State of New Mexico  
Energy, Minerals and Natural Resources

WELL API NO. 30-015-32320
5. Indicate Type of Lease STATE X FEE
6. State Oil & Gas Lease No.
7. Lease Name or Unit Agreement Name CLYDE
8. Well Number 1
9. OGRID Number 4323
10. Pool name or Wildcat UNDES; DELAWARE

**SUNDRY NOTICES AND REPORTS ON WELLS**  
(DO NOT USE THIS FORM FOR PROPOSALS TO DRILL OR TO DEEPEN OR PLUG A DIFFERENT RESERVOIR. USE "APPLICATION FOR PERMIT" (FORM C-101) FOR SUCH PROPOSALS.)

**CONDITIONS OF APPROVAL FOR PLUGGING & ABANDONMENT**

# PURPOSED Wellbore Schematic

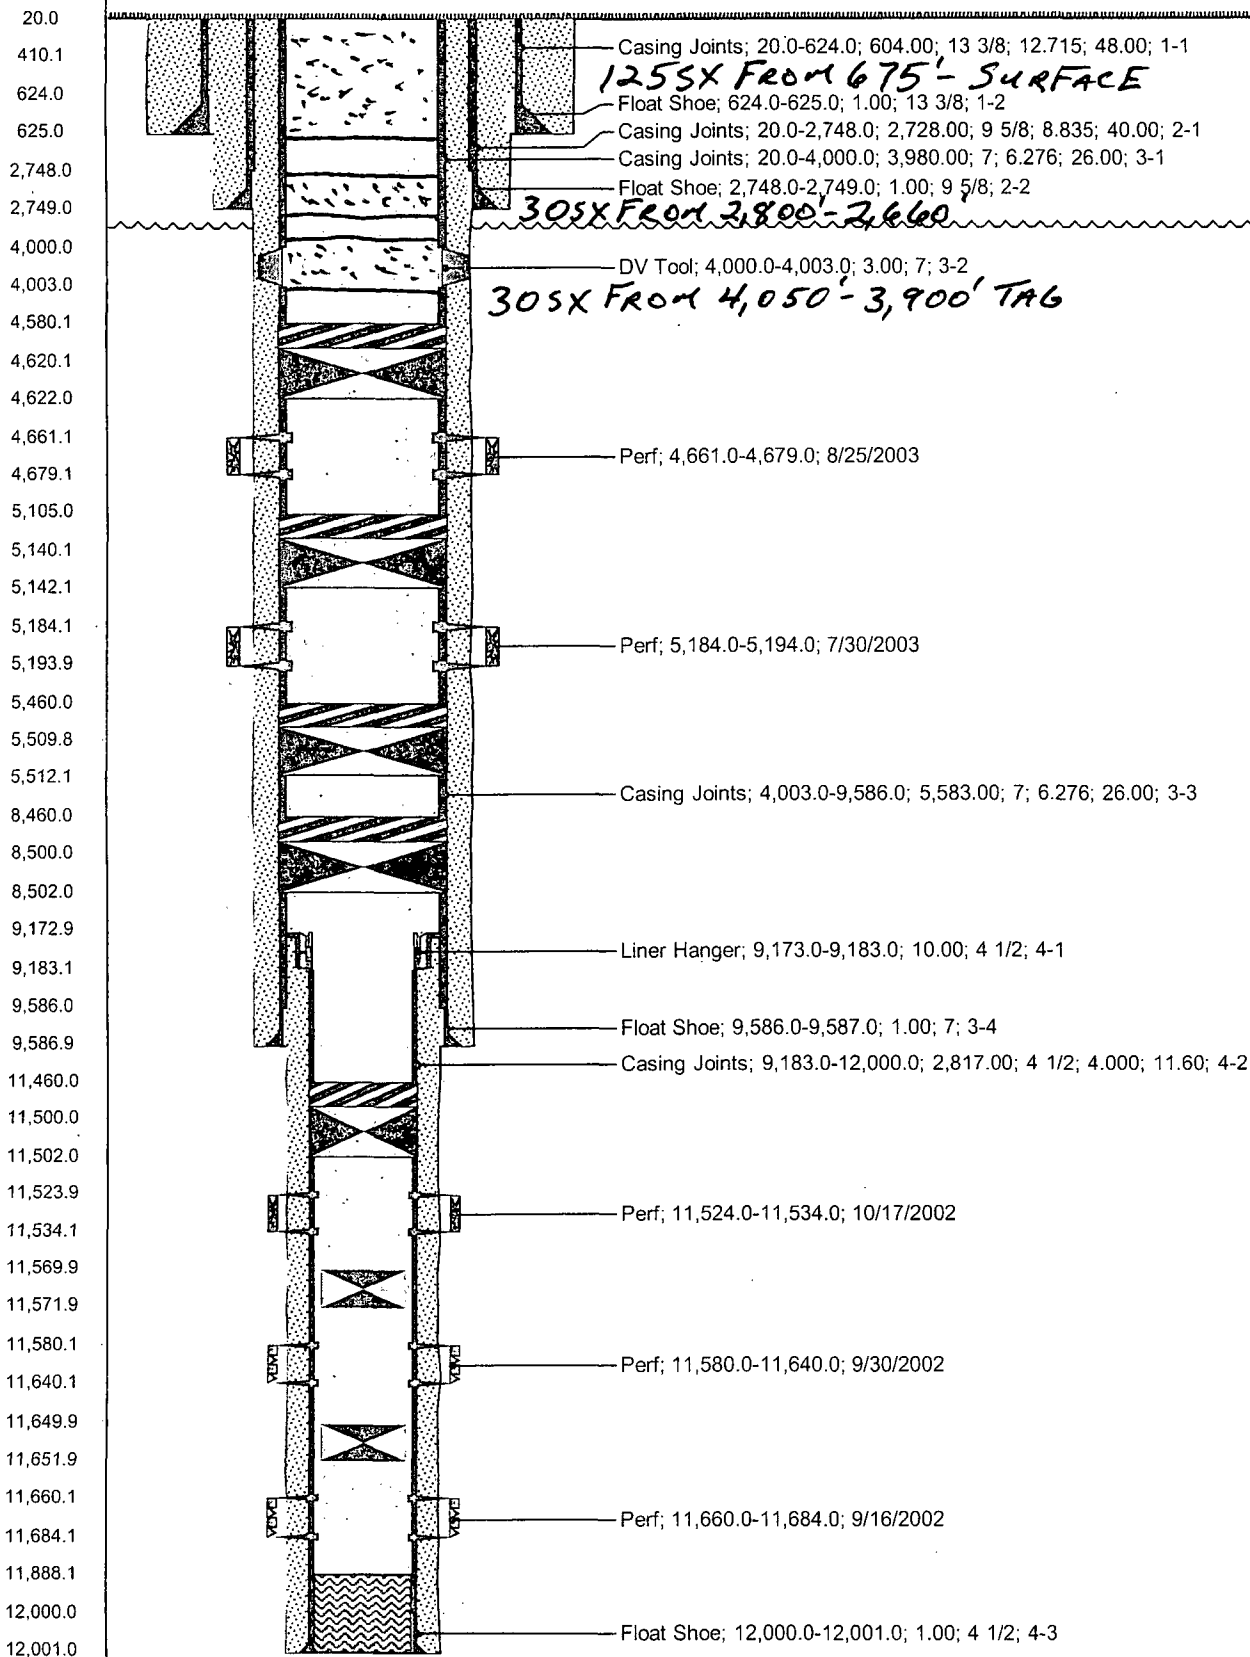
1. Produced water **will not** be used during any part of the plugging & abandonment operation.
2. Notify NMOCD Dist. 2 office at least 24 hrs before beginning work.

3. Closed Loop System is to be used for entire plugging operation. Upon completion, contents of steel pit are to be hauled to a permitted disposal location.

7. Every attempt must be made to clean the well bore out to below the perms, before any plugs can be set, by whatever means possible.
8. **Cement Retainers may not be used.**

9. **Squeeze pressures are not to exceed 500 PSI, unless approval is given by NMOCD.**
10. **Plugs may be combined after consulting with and getting approval from NMOCD.**

11. **Minimum WOC time for tag plugs will be 4 Hrs.**
